AGENDA

IN RE:)
)
140 West 2nd) KETCHUM PLANNING AND ZONING COMMISSION
Design Review) FINDINGS OF FACT, CONCLUSIONS OF LAW, AND
Application File Number: P24-092) DECISION
)
)
Date: March 12, 2024)

PROJECT: 140 West 2nd
APPLICATION TYPE: Design Review
FILE NUMBER: P24-092
ASSOCIATED APPLICATIONS: Pre-Application Design Review P24-070
PROPERTY OWNER: 140 West 2nd Street LLC
REPRESENTATIVE: Michael Doty Associates, Architects
LOCATION: 140 W 2nd Street (Ketchum Townsite: Block 59: Amended Lot 1A)
ZONING: Mixed-Use Subdistrict of the Community Core (CC-2 Zone)
OVERLAY: None

EXTERIOR LIGHTING PLANS AND SPECIFICATIONS

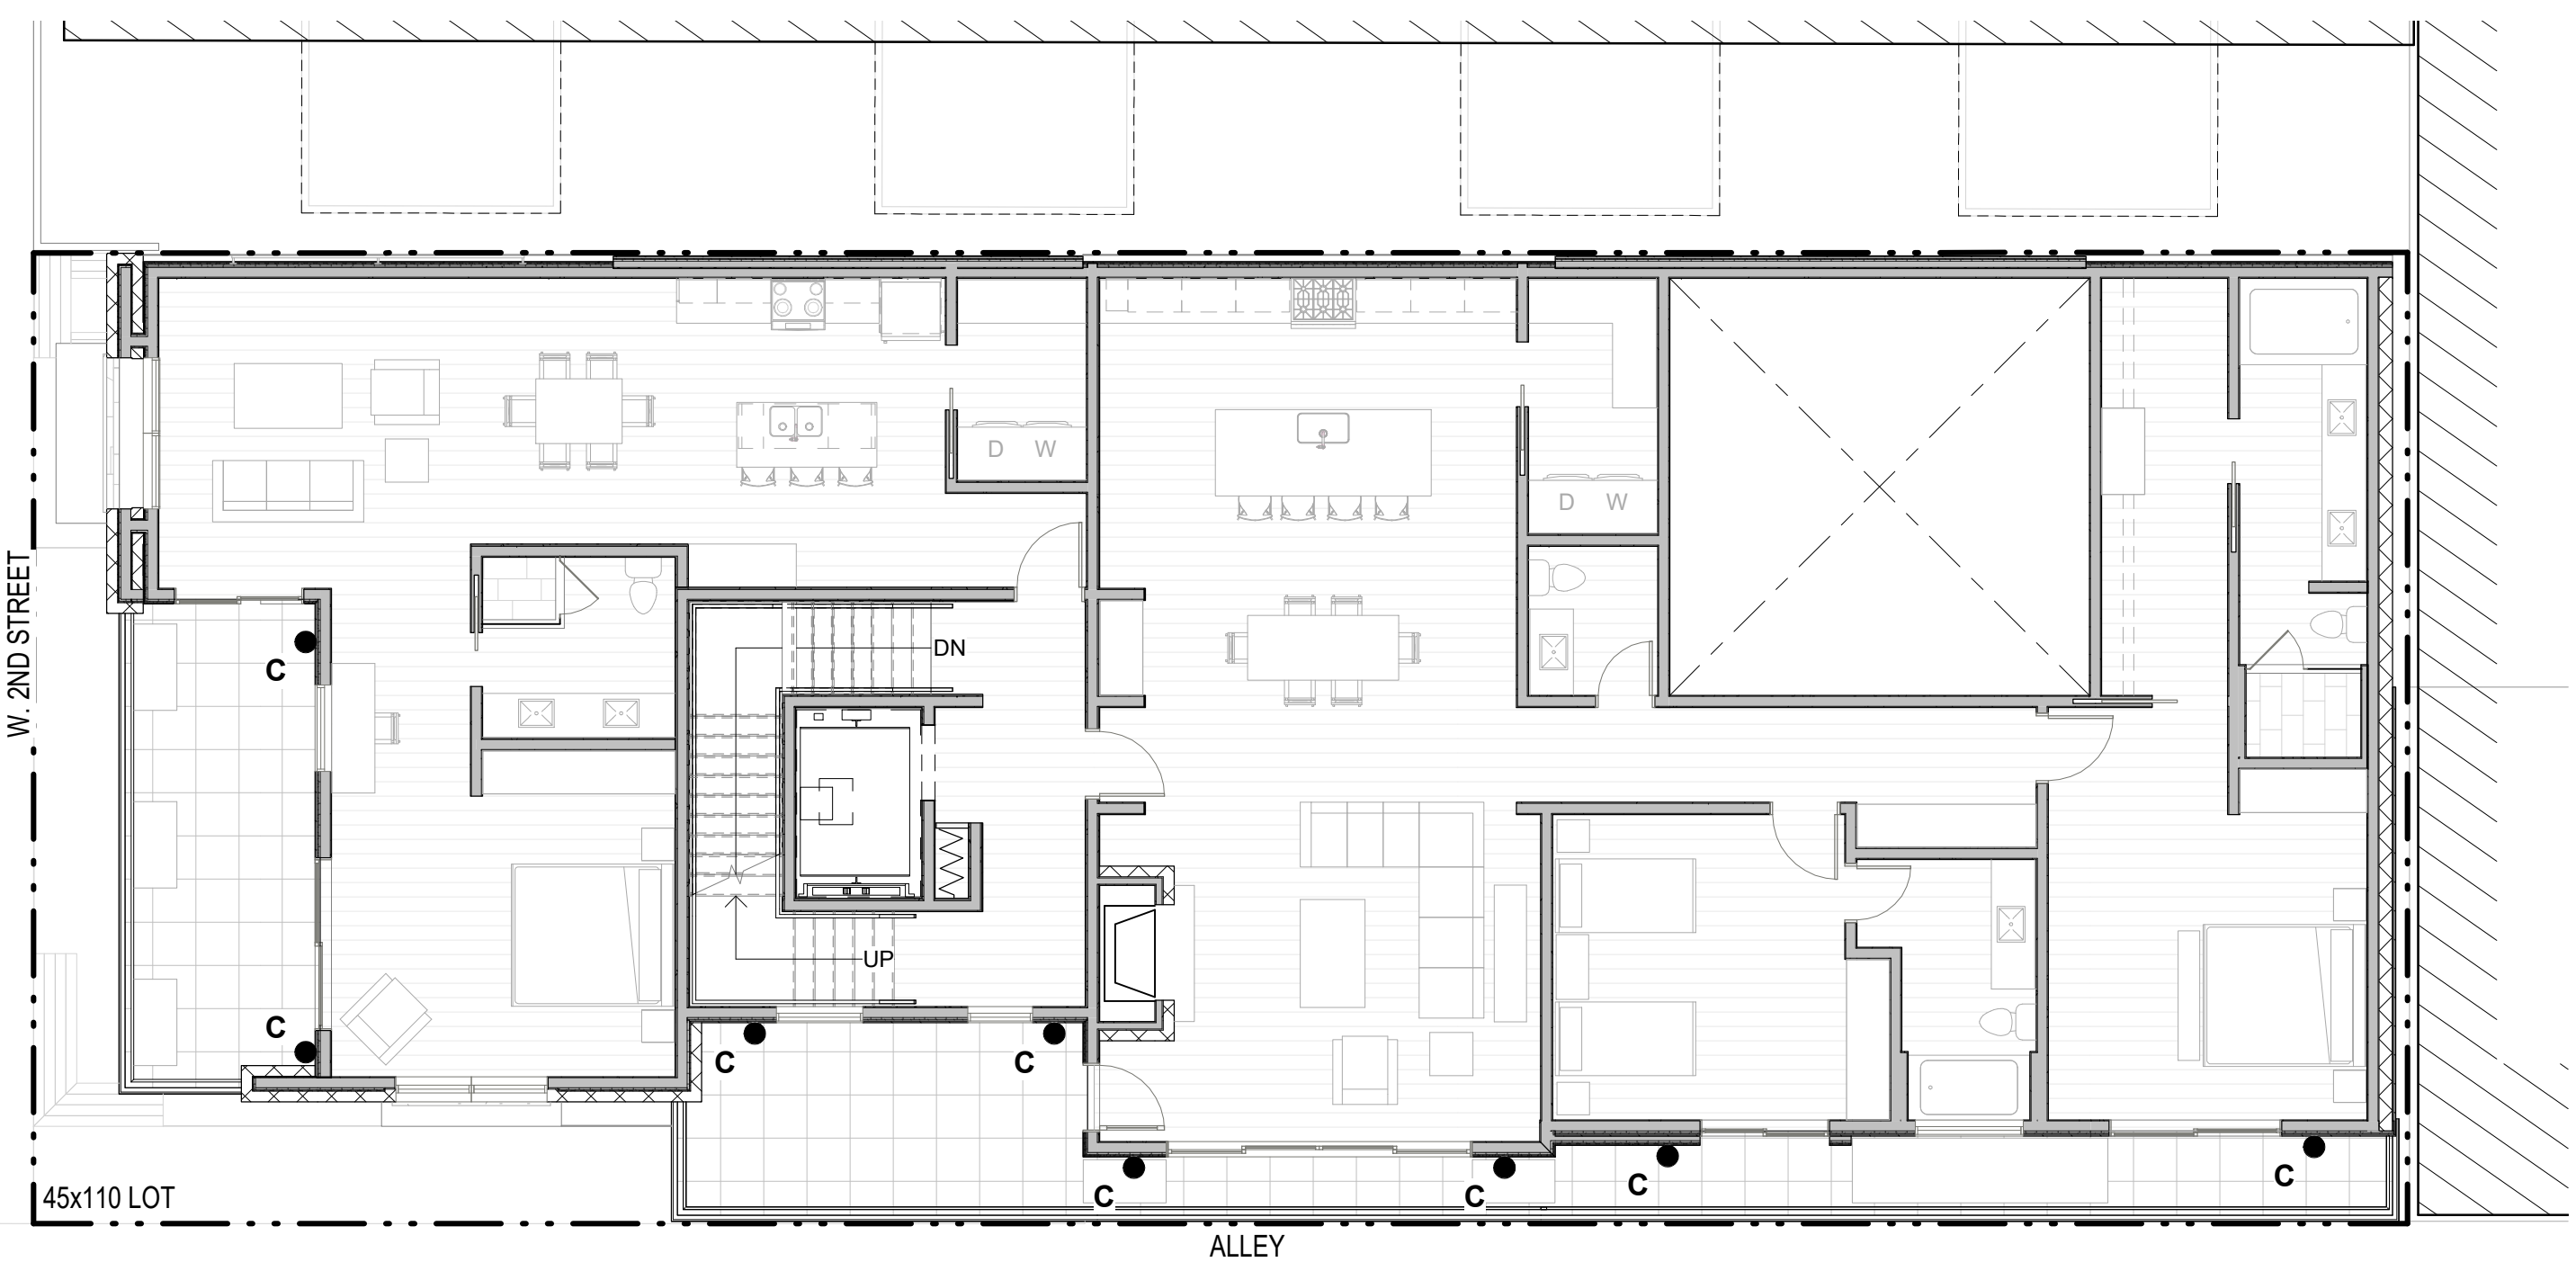
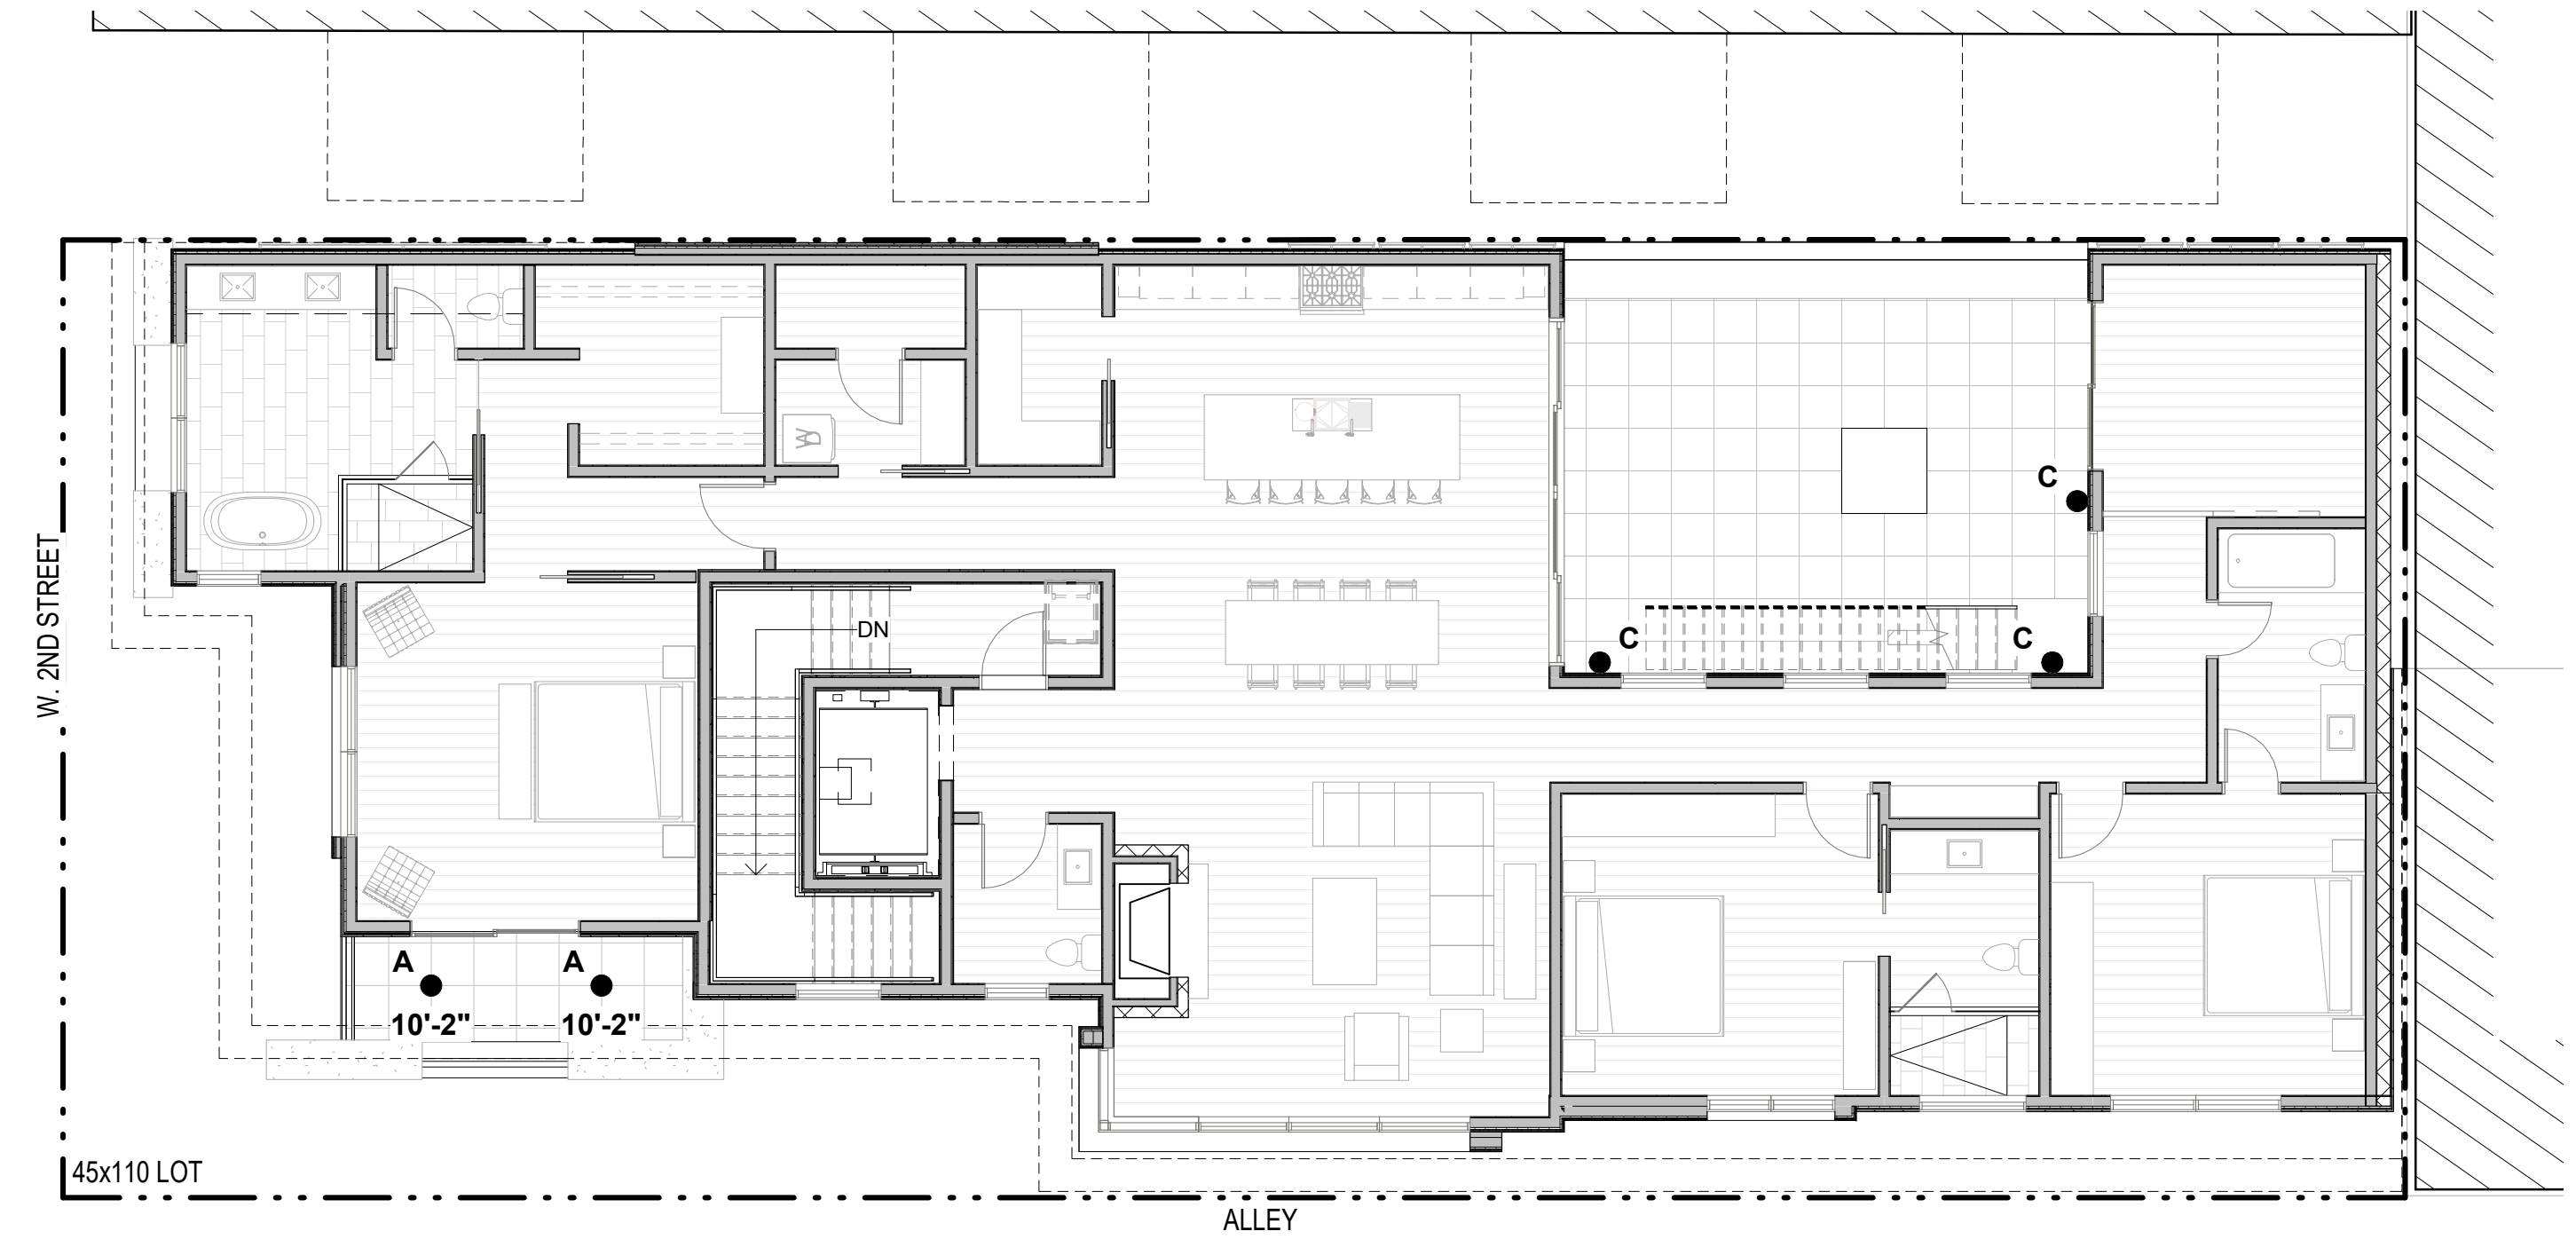
17.132 – Dark Skies	Conformance
<i>Compliance with Section 17.132 – Dark Skies.</i>	YES
<p>Commission Findings: The exterior lighting plan is provided on sheets A-511 & A-512. The exterior lighting fixtures include recessed downlights, path lights, and wall sconces. All exterior lighting is compliant with KMC §17.132.030.H1 as the three fixtures are full cutoff with the light source fully shielded. The light sources used for all three fixtures have a color temperature of 2700 Kelvin, which complies with KMC §17.132.030.A. The photometric study for the on-site exterior lighting shows minimal light trespass along the alley. The light trespass over the west property line along the alley ranges from 0.1 to a maximum of 0.5 footcandles. The light trespass along the alley is consistent with the city’s standards for right-of-way lighting, which requires that the footcandles illuminating the sidewalk shall not exceed an average of 0.2 footcandles and shall not exceed 5 footcandles.</p>
